Request for Information 0140

CCSF Reservoir Site Work Project # 62970200 Bovis Lend Lease, Inc.
Tel: Fax:

Table with 3 columns: Subject, Discipline, Category. Subject: Solid lines on the north side of Parking Lot Q and JUF in Civil Drawing C2.50R. Discipline: Civil. Category: Drawing Clarification.

**C2.50R2**  
JOB NO: 06024-1 OF SHEETS

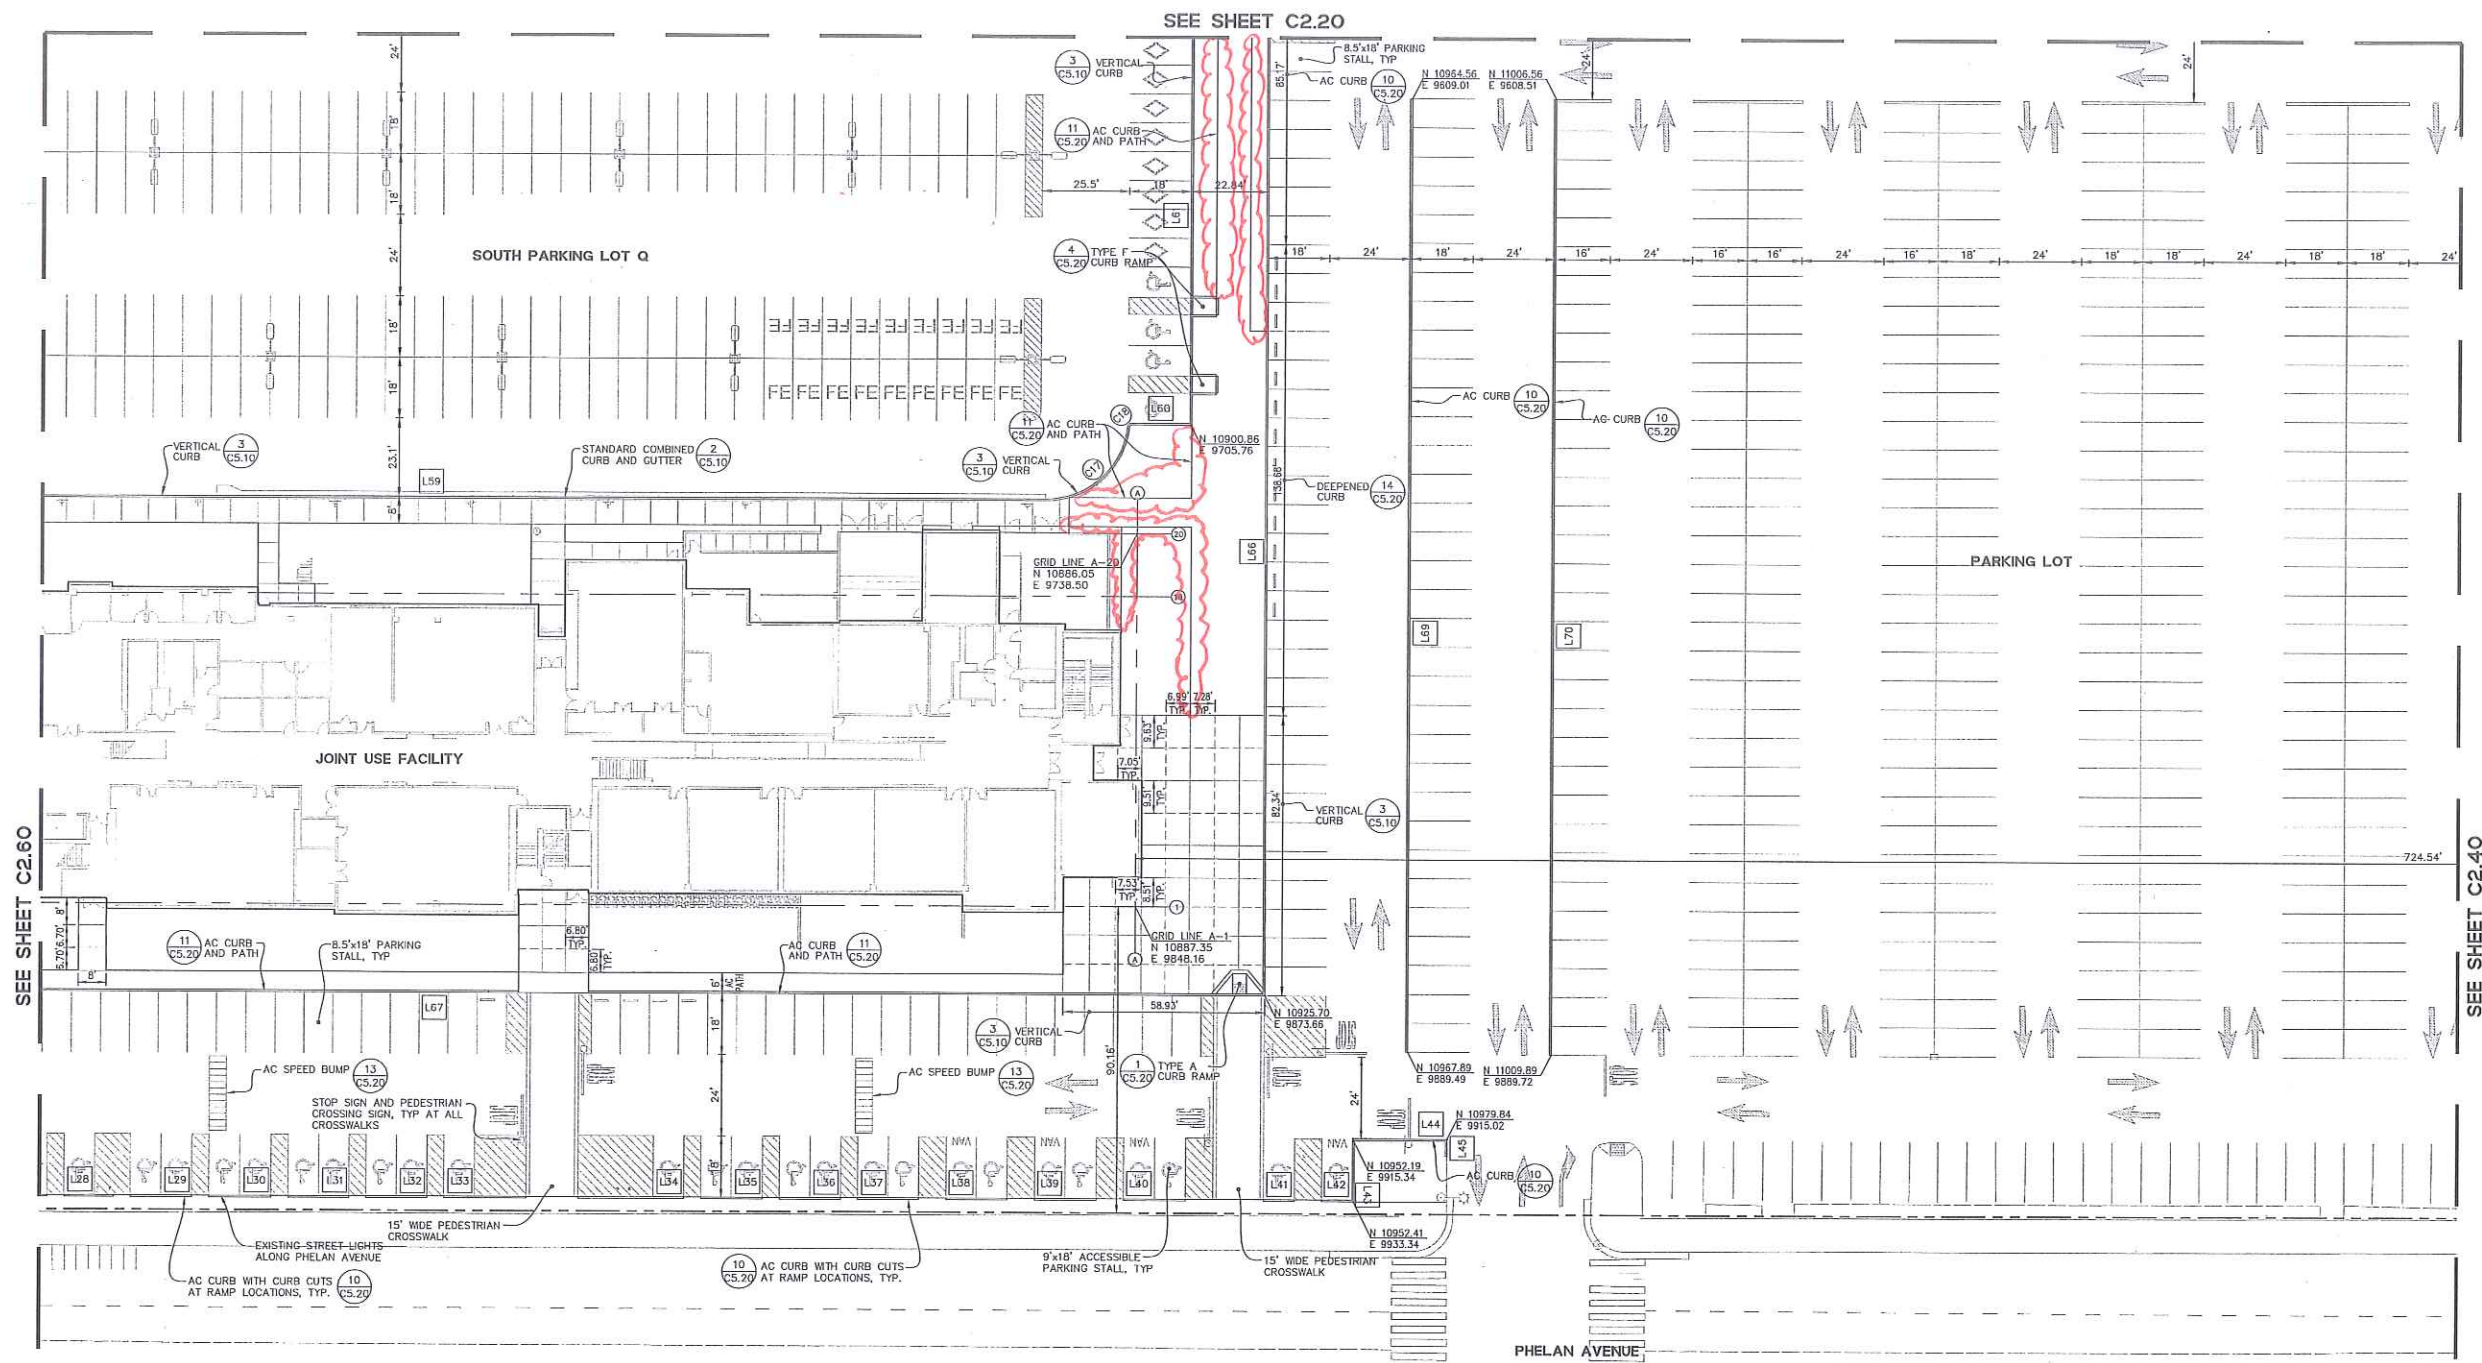
Please clarify the solid lines(in cloud area) on north side of Parking Lot Q and JUF whether are AC curbs or not in the attached sketch.

Solid lines represent the edge of 2" thick AC pavement and delineate the AC paving from the no mow fescue. There is no AC curb to be installed in the indicated areas. Refer to sheet C1.90R2 for more information.
